# **Monitoring Report MY04**

**Cedar Branch Restoration Site  
Monitoring Year 04  
DMS Contract 6598  
DMS Project Number 97009**

## MEMORANDUM

Subject: Cedar Branch Stream Restoration Site  
MY-04 Monitoring Report Comments  
Yadkin River Basin CU 03040103  
Randolph County, North Carolina  
NCDMS Project # 97009  
Contract # 006598

**CURRENT  
 CONDITION  
 PLAN VIEW**

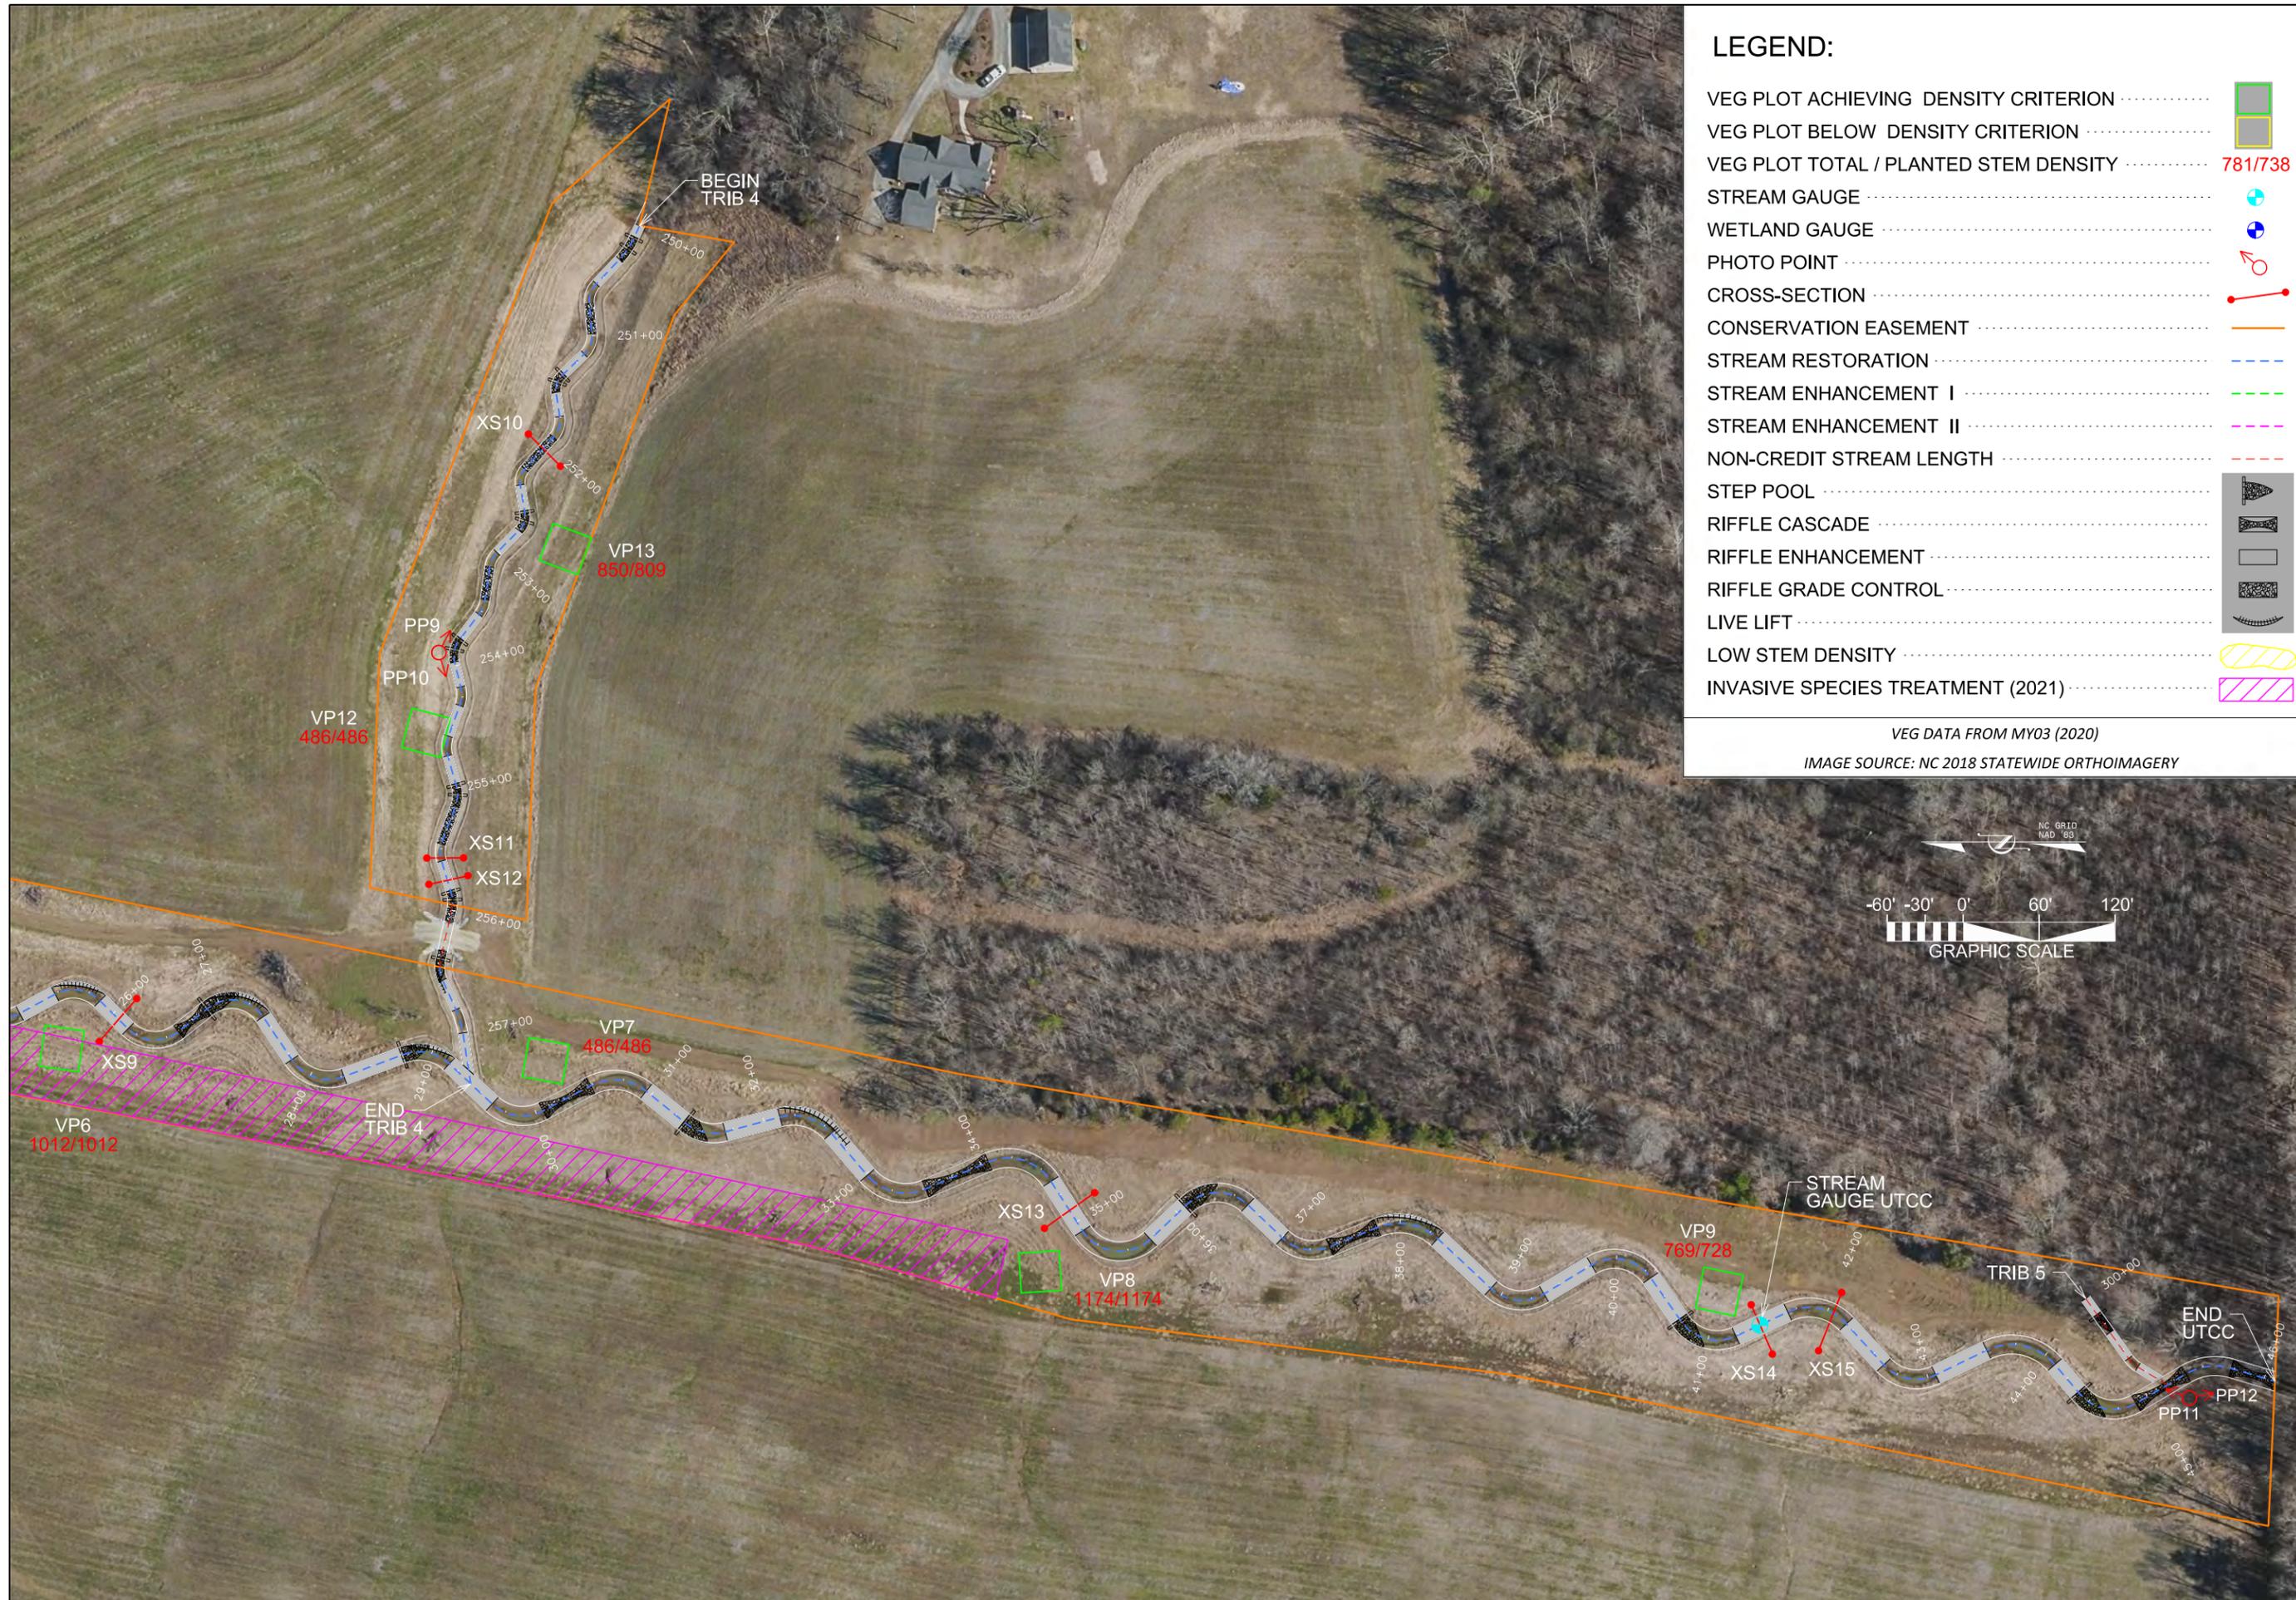
Digital Deliverables: Please submit polygon features (e.g. shapefile, feature class) that characterize the low stem density area.

- *A polygon was created to represent the low stem density area.*

### Cedar Branch Restoration Site Hydrograph T1-1 Stream Flow Gauge

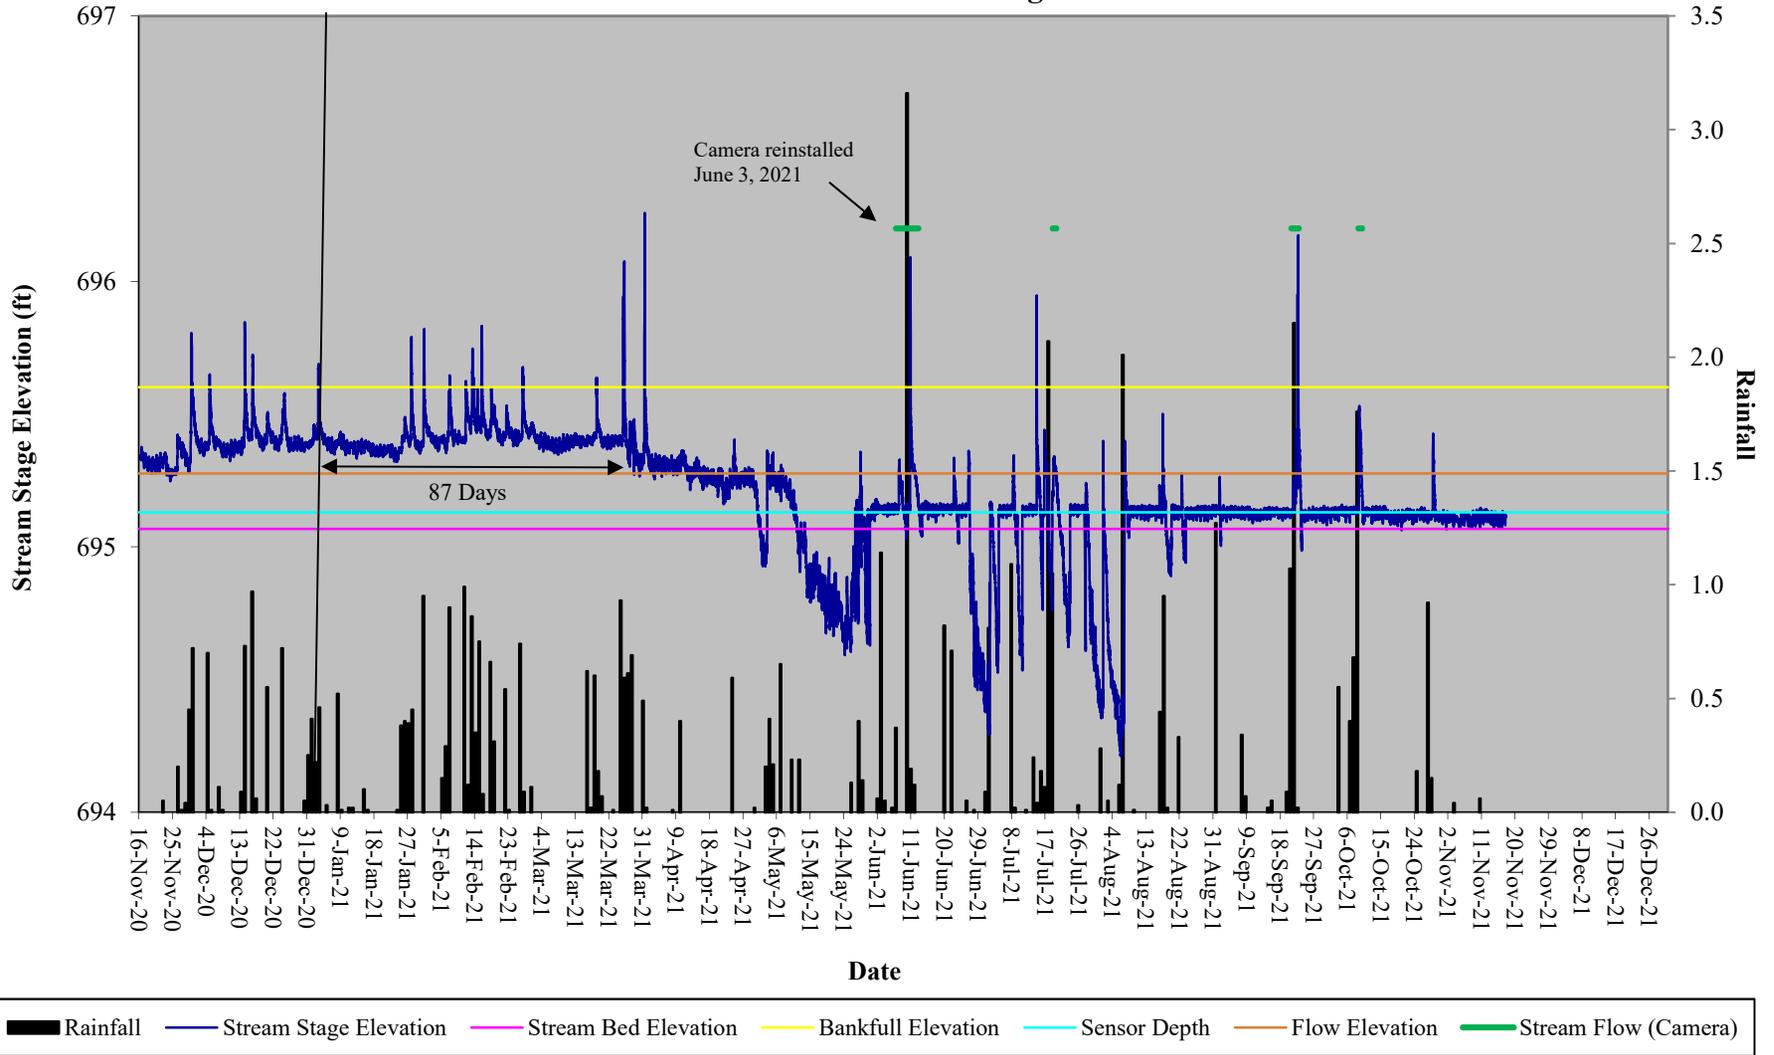
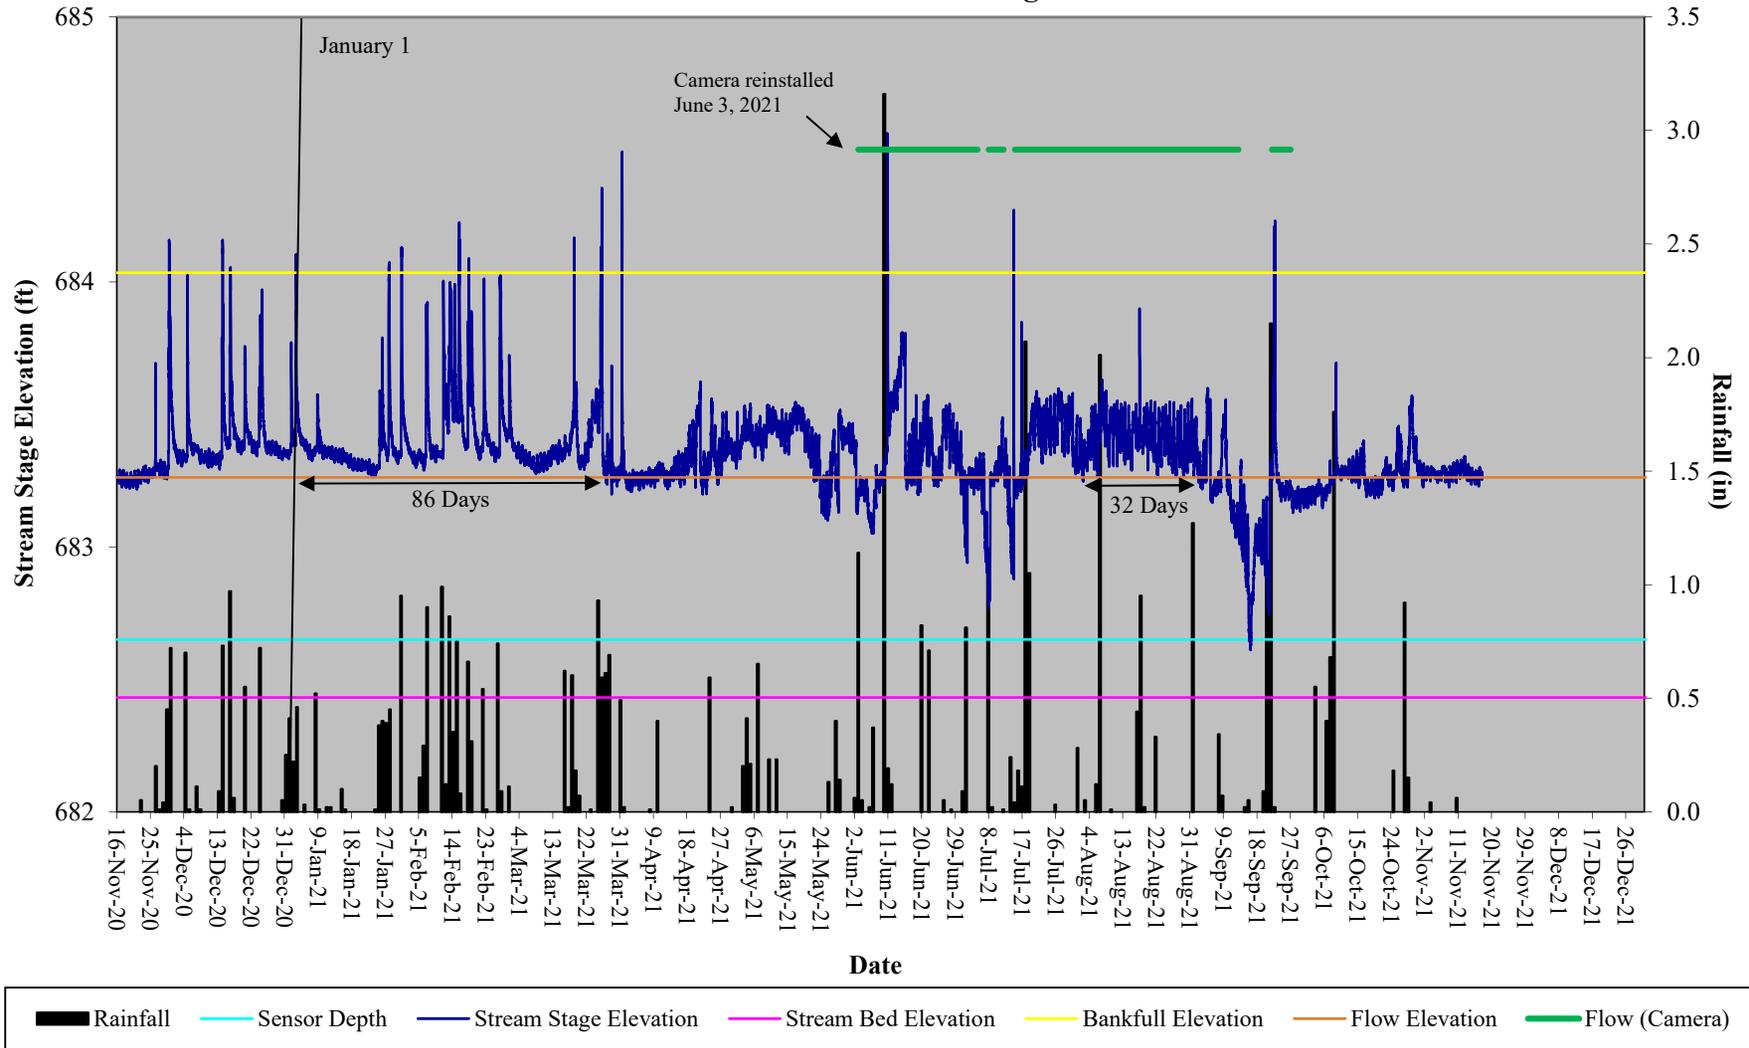
Camera on T1-1 malfunctioned and only recorded 7 days according to report. Has all equipment been repaired/replaced and functioning correctly moving into MY5? Please add a short statement regarding the status of the monitoring equipment to this section.

➤ *The camera on T1-1 malfunctioned from January 1 to June 3 of 2021. The camera was replaced on June 3, 2021 and had a maximum of seven consecutive flow days and a total of 15 days of flow. The camera malfunctioned during the wetter part of the growing season and since the gauge on T1-1 was flowing for 87 consecutive days one can assume that the camera would have recorded flow days during that time if it had been working properly. All cameras and gauges will be working properly before the growing season for Monitoring Year 5.*
